**NATIONAL RESEARCH COUNCIL OF CANADA
ASSOCIATE COMMITTEE ON THE
NATIONAL BUILDING CODE**

**ERRATA AND REVISIONS
to the
CANADIAN PLUMBING CODE
1970**

**Ottawa
1 July 1972**

Figure 21 T-Y fittings in drainage systems

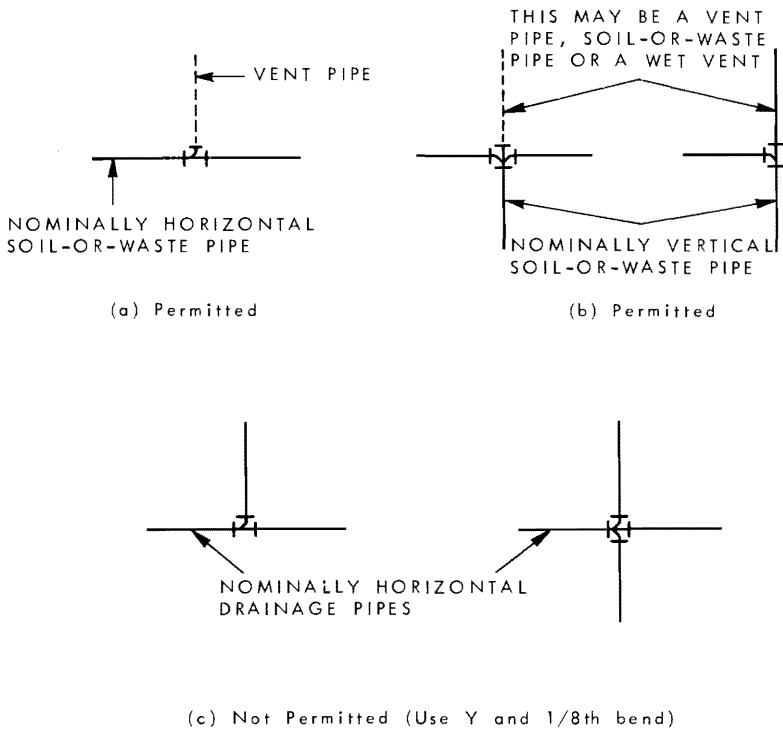
25	7.2.4.3.	Add the following explanatory note and new Fig. 21 after Article 7.2.4.3. A T-Y fitting may be used to change the direction of flow in a drainage system from horizontal to vertical but may not be used to change the direction of flow in a <i>nominally horizontal</i> drainage system.
26	7.2.4.4.	Delete existing article and explanatory note following the article.
26	7.2.4.	Add new Article 7.2.4.5. as follows and renumber existing Article 7.2.4.5. as Article 7.2.4.6. and Article 7.2.4.6. as Article 7.2.4.7.: "7.2.4.5. A Y and 1/8th bend fitting may be used to connect a <i>fixture drain</i> whose <i>diameter</i> is more than 2 in. to a <i>continuous vent</i> or <i>nominally vertical soil-or-waste pipe</i> that serves as the <i>vent pipe</i> ." (See Fig. 21b, Page 25.)
26	7.2.5.1.(1)(b)	In the first line change "CGSB 34-GP-22, 1966" to read "CGSB 34-GP-22a, 1970".

Figure 55 Basement floor drains

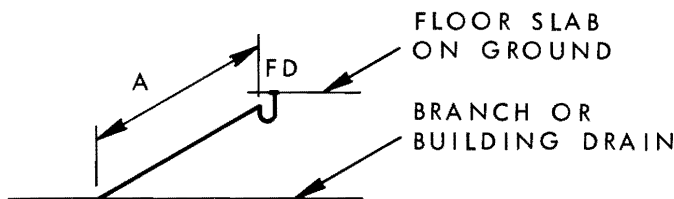
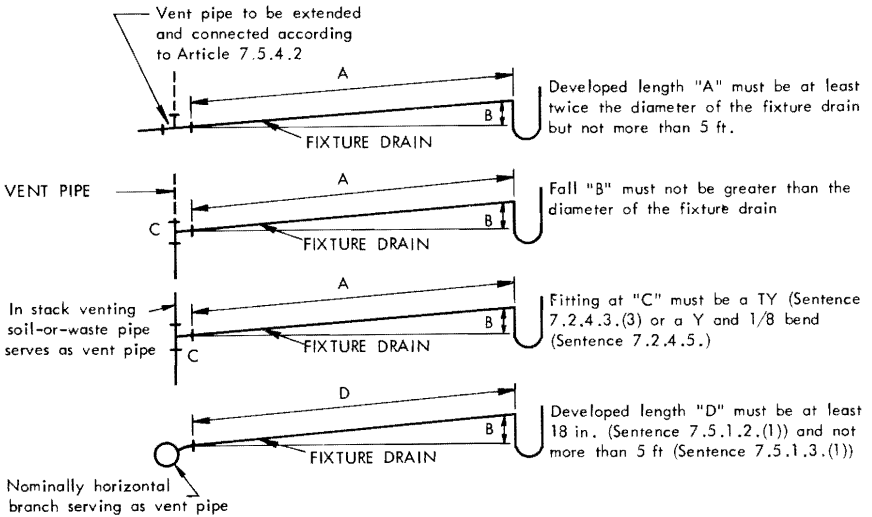
75	Figure 55	Delete and substitute the following explanatory note and new Fig. 55. "The <i>developed length A</i> of the <i>fixture drain</i> shown in Fig. 55 must be at least 18 in. long. Its length in feet should not exceed its <i>diameter</i> in inches divided by its slope in inches per foot. For example, the maximum length of a <i>fixture drain</i> set at a slope of 1/4 in. per ft for a 3 in. floor drain is 12 ft.
